UNITED STATES ENVIRONMENTAL PROTECTION AGENCY
Region 5

G&H INDUSTRIAL LANDFILL SITE
Macomb County, Michigan

FIVE-YEAR REVIEW (Type I)

Figure 1: G&H Industrial Landfill, Macomb County, Michigan

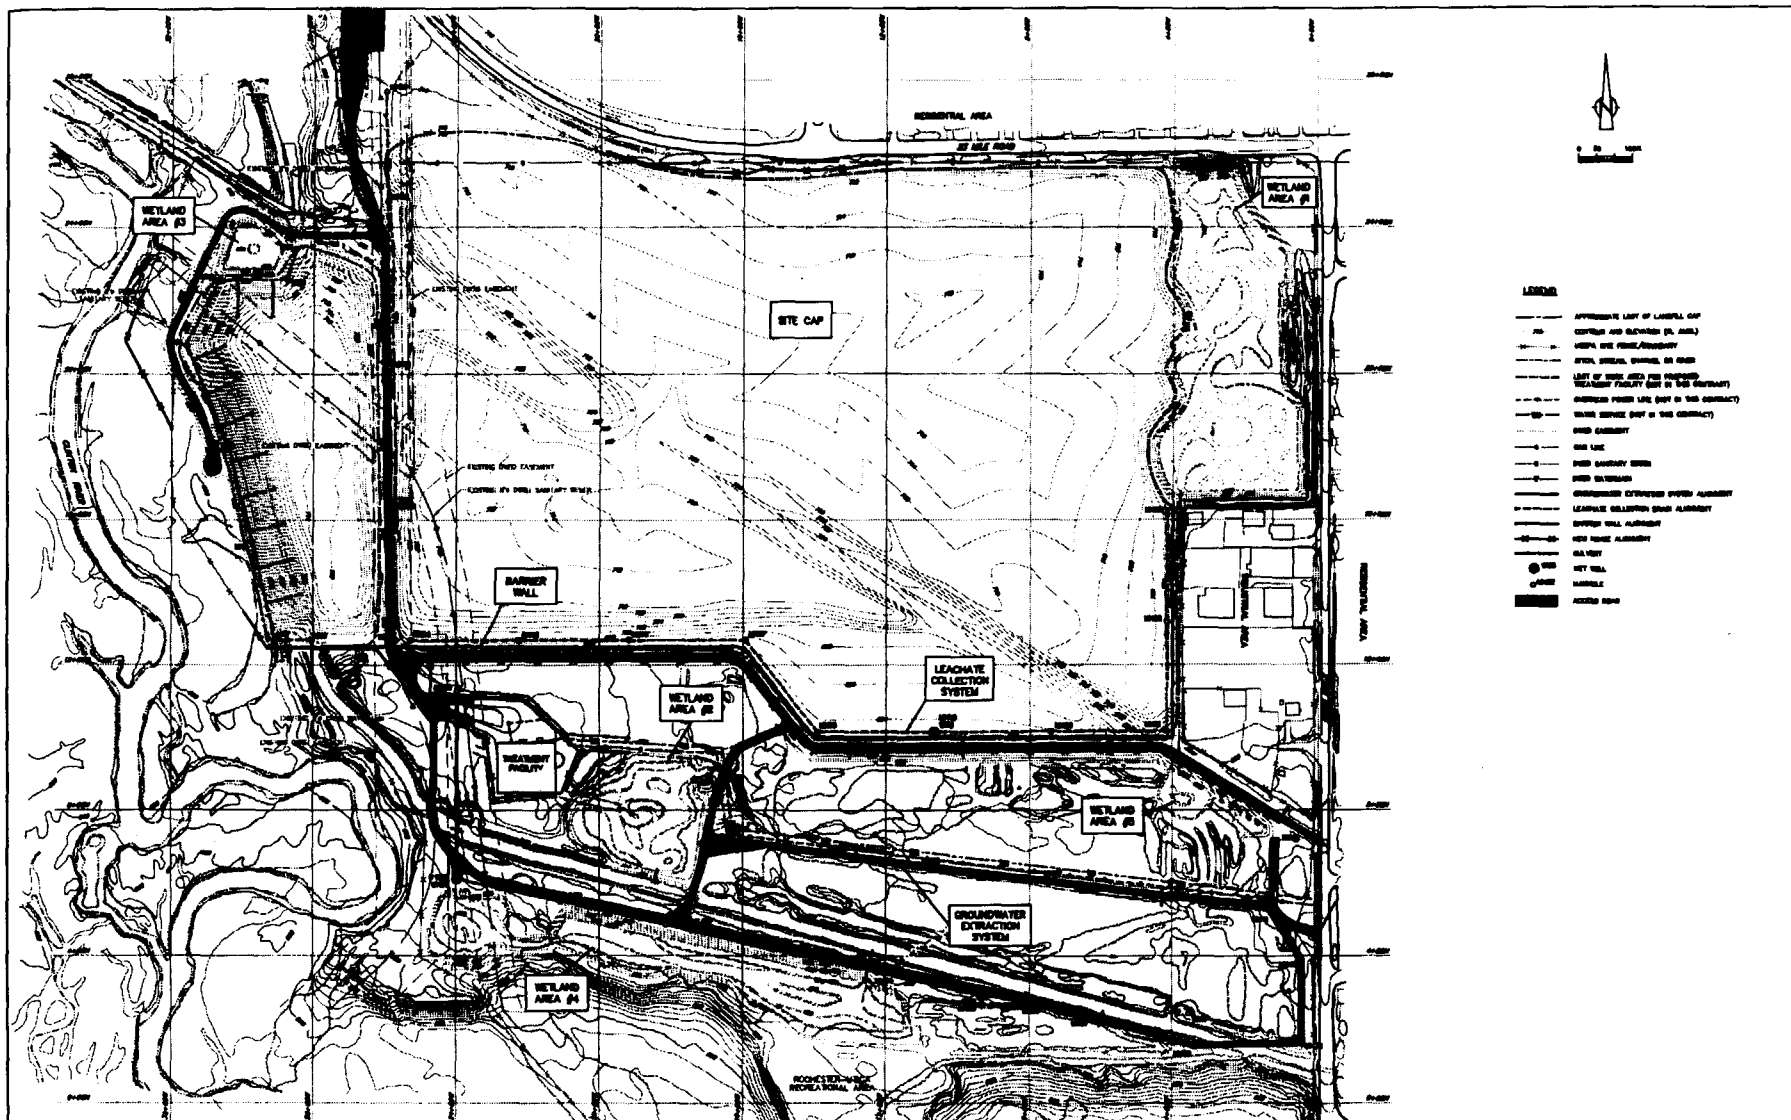
Review of the quarterly reports show that contaminant levels are remaining steady in the downgradient groundwater plume, both in the area subject to the extraction system (see Figure 1) and in the area that the modified natural attenuation remedy is being tested. MDEQ has recommended that the groundwater monitoring program be modified to strengthen the data gathering effort in this area to more conform with monitored natural attenuation policies and guidelines.

The landfill cap drainage layer along the Phase III landfill area (see Figure 1) is leaking water during high rain events. Although this seems to be a normal event in accordance with the design of the landfill cap system, some of the pooled water below the "daylight" pipes is orange-stained (likely due to iron bacteria) and there is a question as to whether the water contains leachate along with the rainwater. The Group has proposed a sampling event to test the water for leachate and later intrusive investigative work may be performed if leachate is actually noted in the water samples.
